Site 3 - Australia Towers II
Sydney Olympic Park

Approved Section 75W Modification Application

No. **MOD 4** granted on the **7/10/14**

in respect to MP **10-0027**

Site 3 - Australia Towers II
Sydney Olympic Park
Level 01

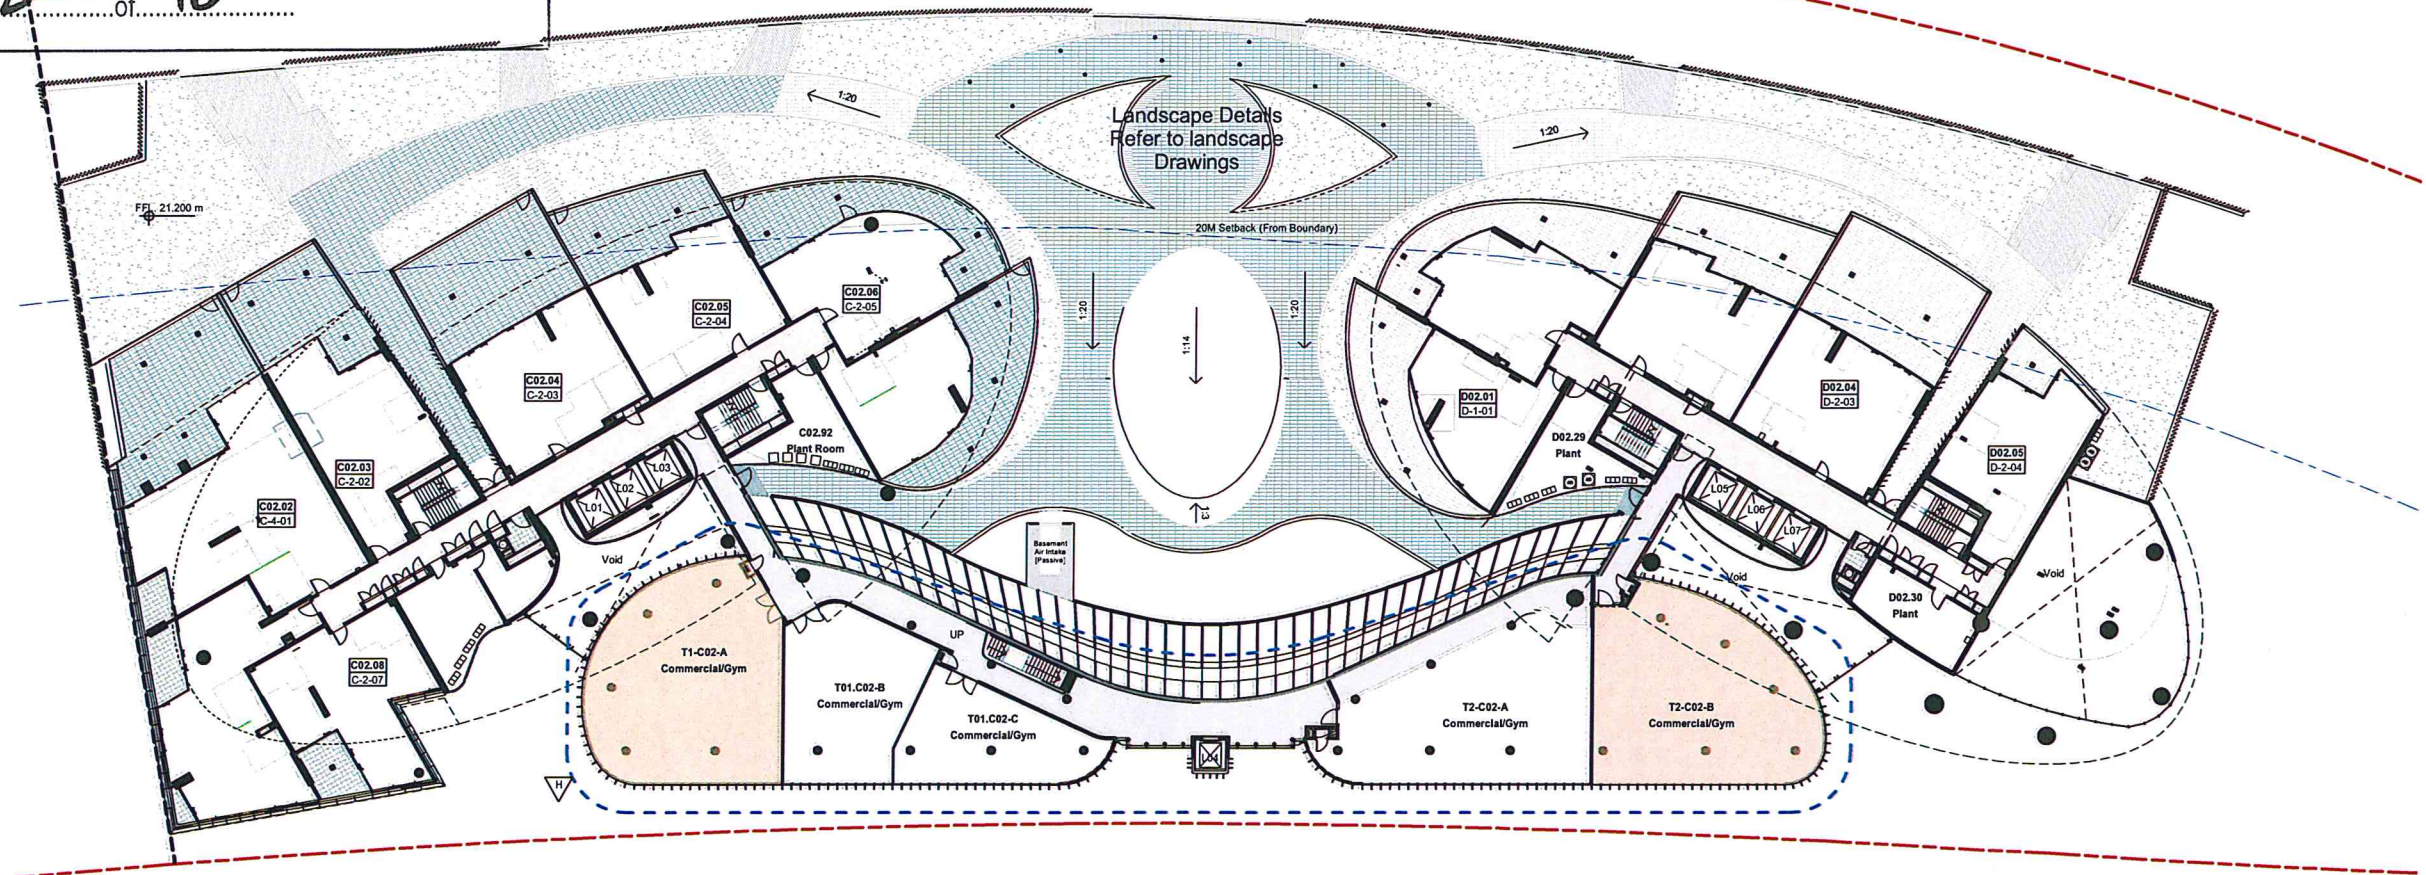
- STW Revision Notes:**
- Tower C
- 1 additional unit at L24.
 - Tower D
- 2 additional units at L30.
- Lift Motor Room revised.
 - Common Area
- L00L01 Retail and Commercial layout revised.

GA Plan - C - Level 24

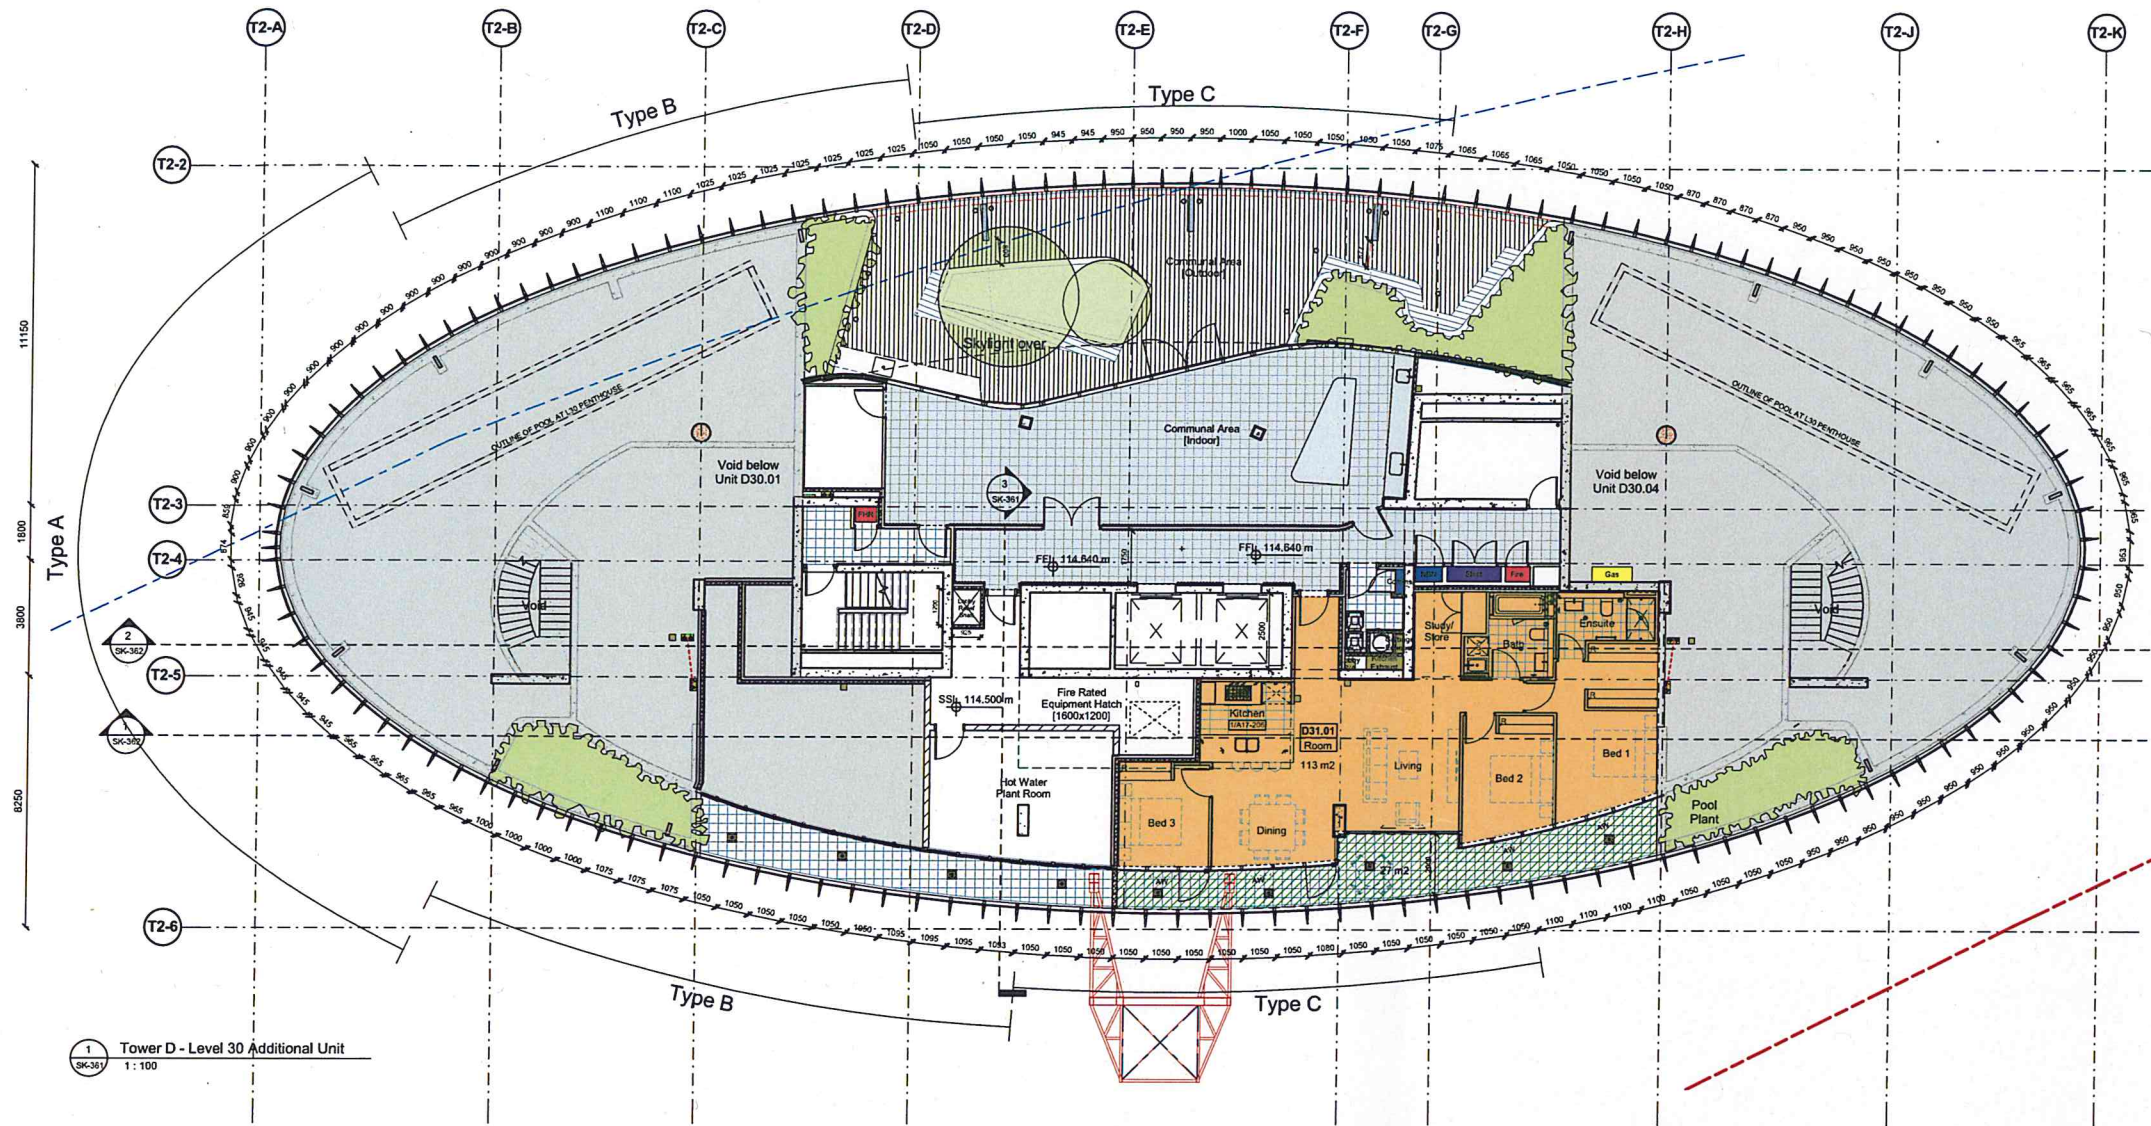
Notes:
Additional apartment units - C25.08 and C25.09

Site 3 - Australia Towers II
Sydney Olympic Park
North & South Elevation

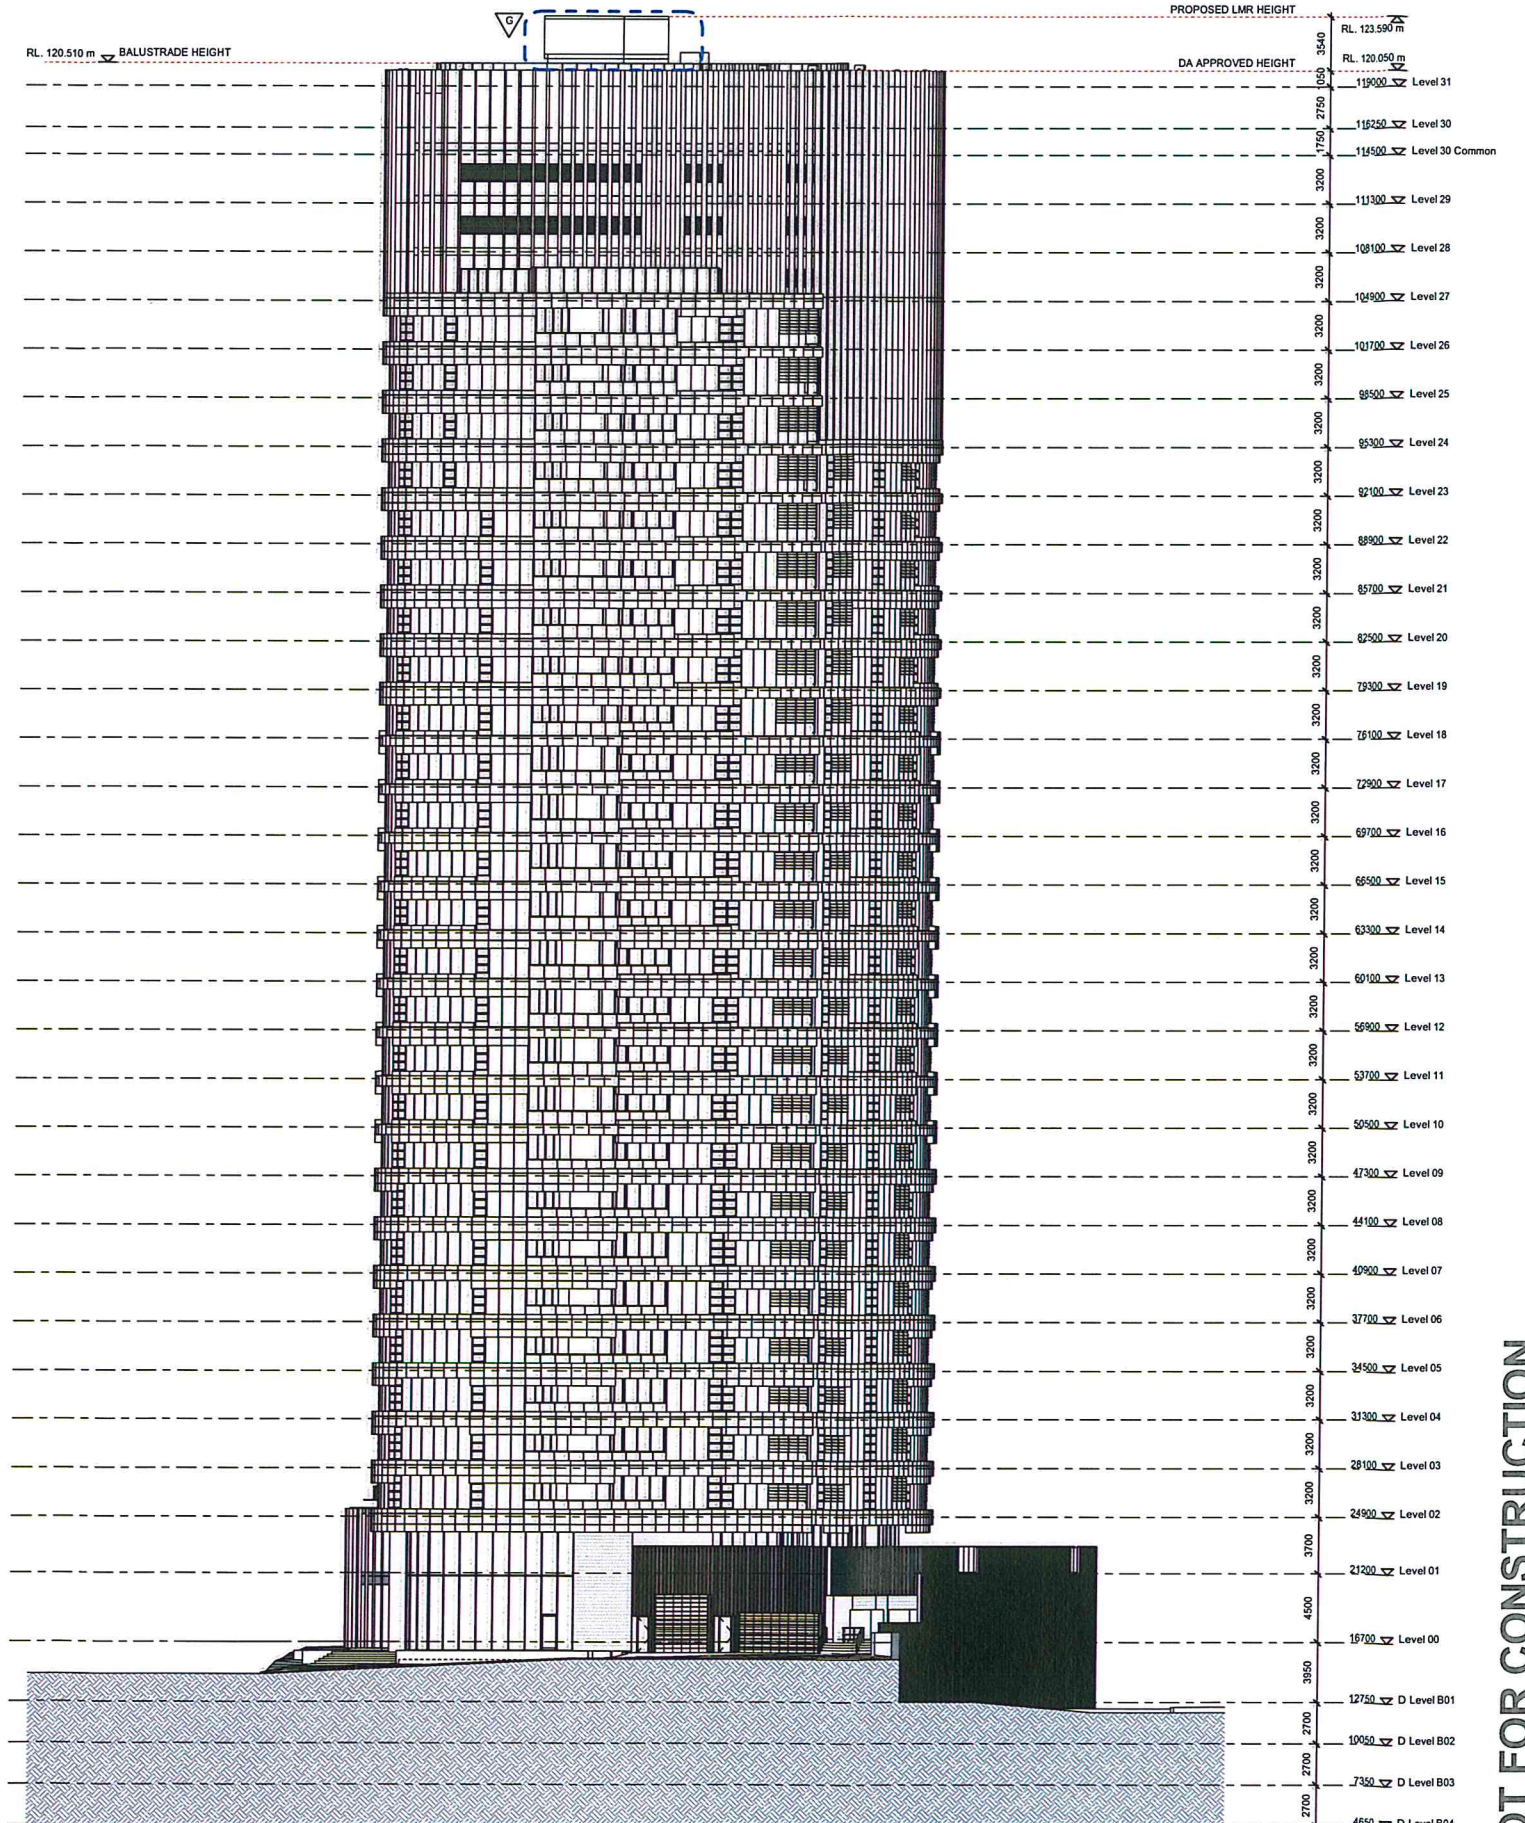
- 575W Revision Notes:**
- Tower C
- 1 additional unit at L24.
 - Tower D
- 2 additional units at L30.
- LR Motor Room revised.
 - Common Area
- L00/L01 Retail and Commercial layout revised.

Site 3 - Australia Towers II
Sydney Olympic Park
West Elevation

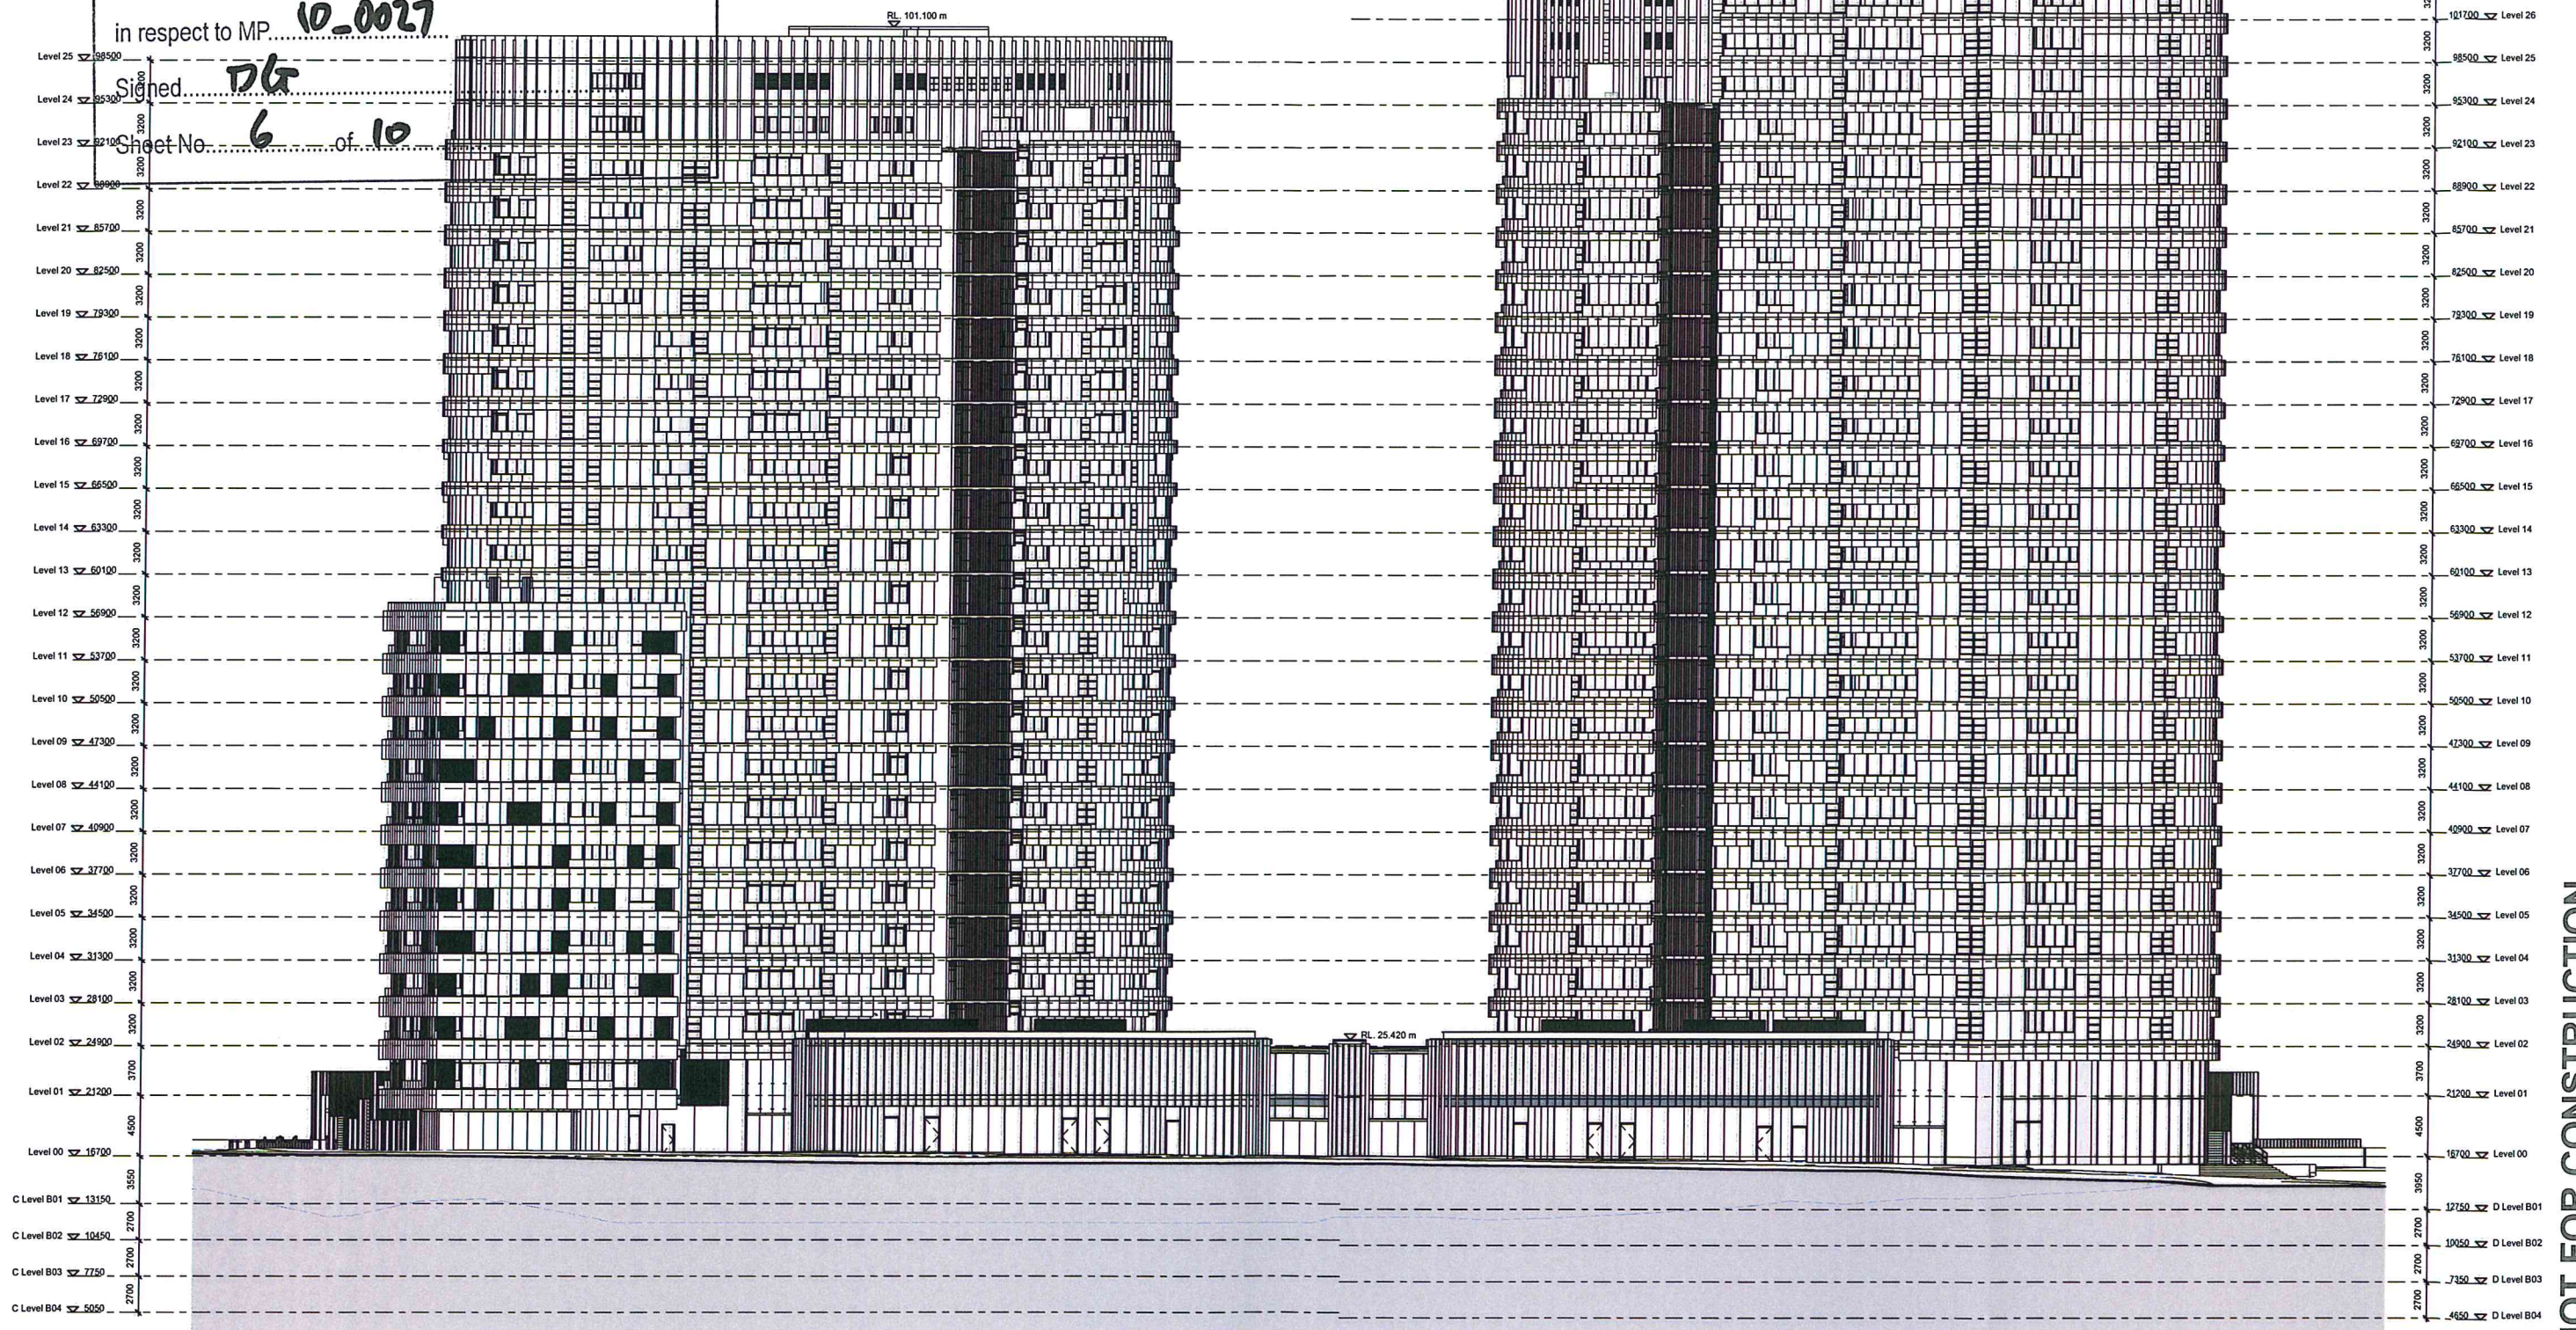
- 75W Revision Notes:**
- Tower C
- 1 additional unit at L24.
 - Tower D
- 2 additional units at L30.
- LR Motor Room revised.
 - Common Area
- L00/L01 Retail and Commercial layout revised.
